**Honor Our Pueblo Existence (H.O.P.E),
Concerned Citizens for Nuclear Safety (CCNS), and
Robert H. Gilkeson, Independent Registered Geologist**

August 20, 2013

Re: Comments for the August 20, 2013 Meeting with the Defense Nuclear Facilities Safety Board in Santa Fe, New Mexico

Seismic Hazard Curves For Peak Horizontal Ground Motions From Simultaneous Ruptures From A Single Earthquake At the location of LANL PF-4, the RLUOB and the proposed CMRR-NF. Source: Figure 7 in the LANL 2009 PSHA Report.

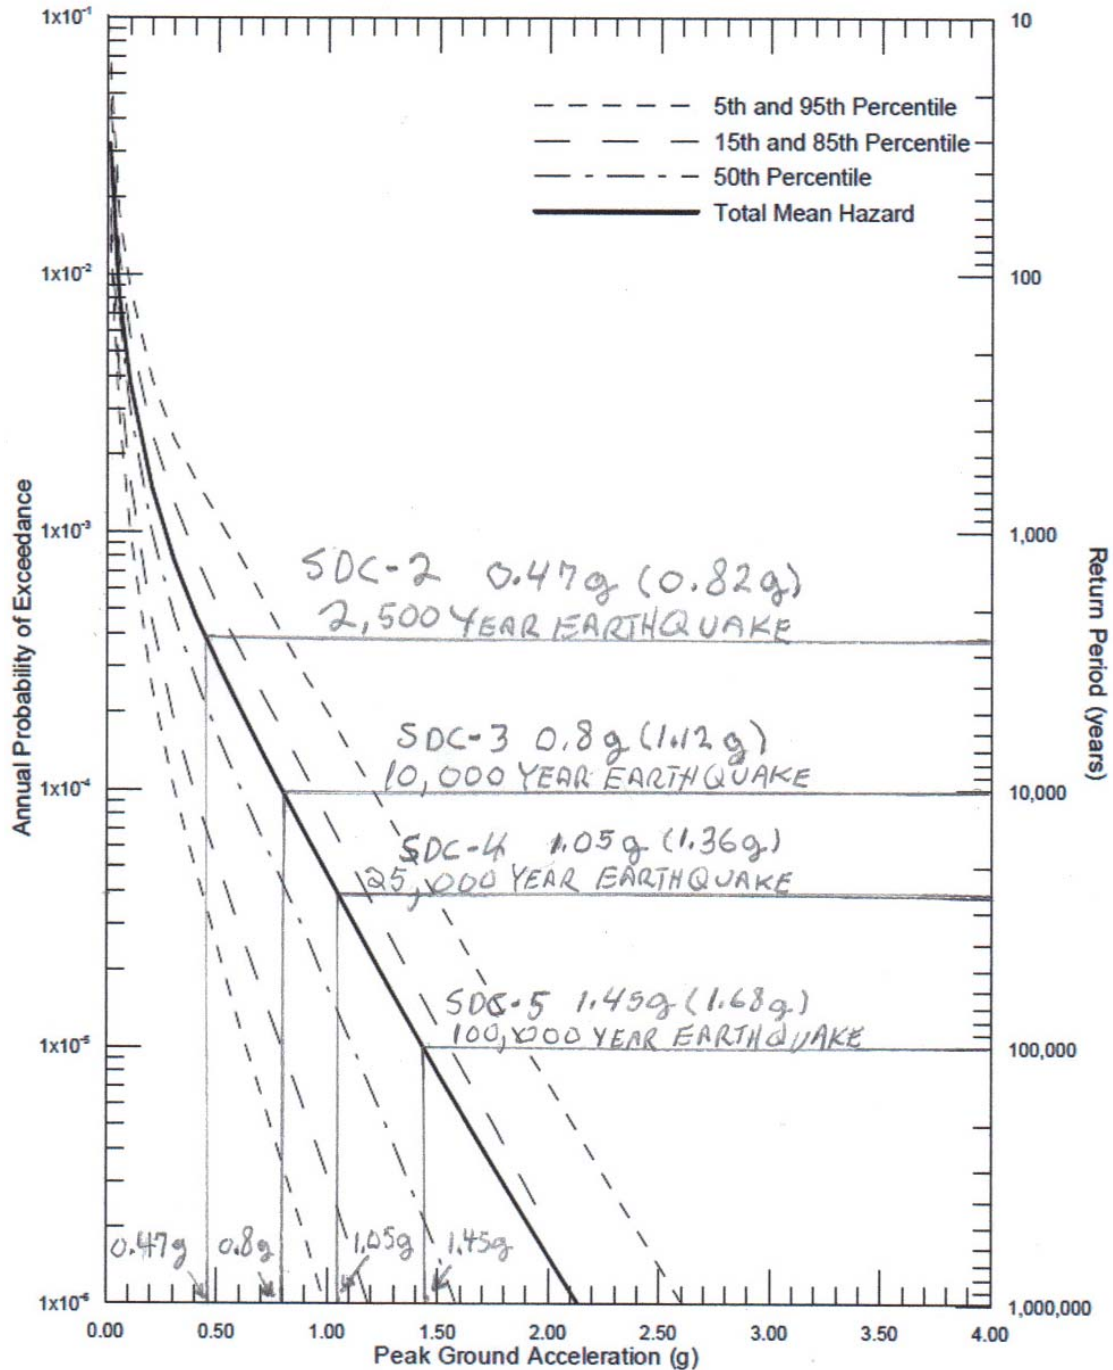
A graph of the large earthquake ground motions calculated in the LANL 2007 and 2009 Probabilistic Seismic Hazard Analysis (PSHA) Reports is attached to this report.

Note: The larger ground motions for synchronous earthquakes for each earthquake return period are in parentheses on the figure. The synchronous ground motions were calculated from Figure 8.
